Service Letter

Bulletin: 40003
Date: 10 March 2009 Revised (10-12)
Product: Compressors
Subject: Zenith harness connectors - Inlet heater

Figure 1

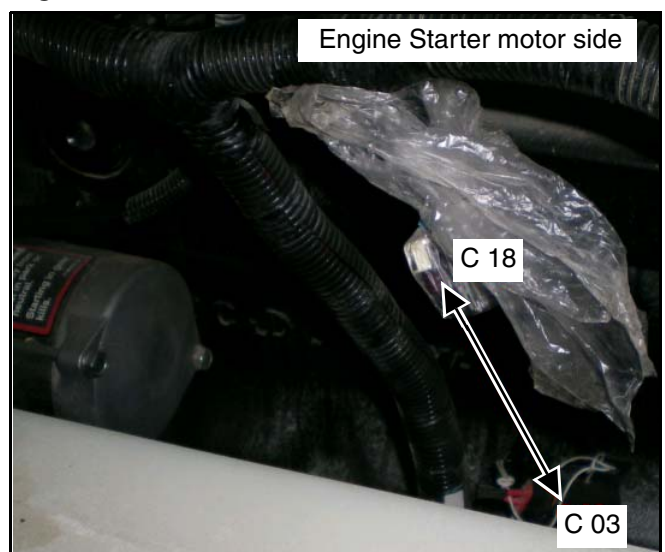
Two connectors which should have been connected to the engine wiring harness have been erroneously left disconnected and secured to the compressor harness.

This will leave the engine intake heater inoperable.

- Disconnect battery.
- Remove blanking plug from engine harness connectors C02 and C 03.
- Remove plastic bags from compressor harness connectors C18 and C07.
- Clean all connectors with dielectric spray.
- Plug connector C18 into connector C03. [Figure 1]
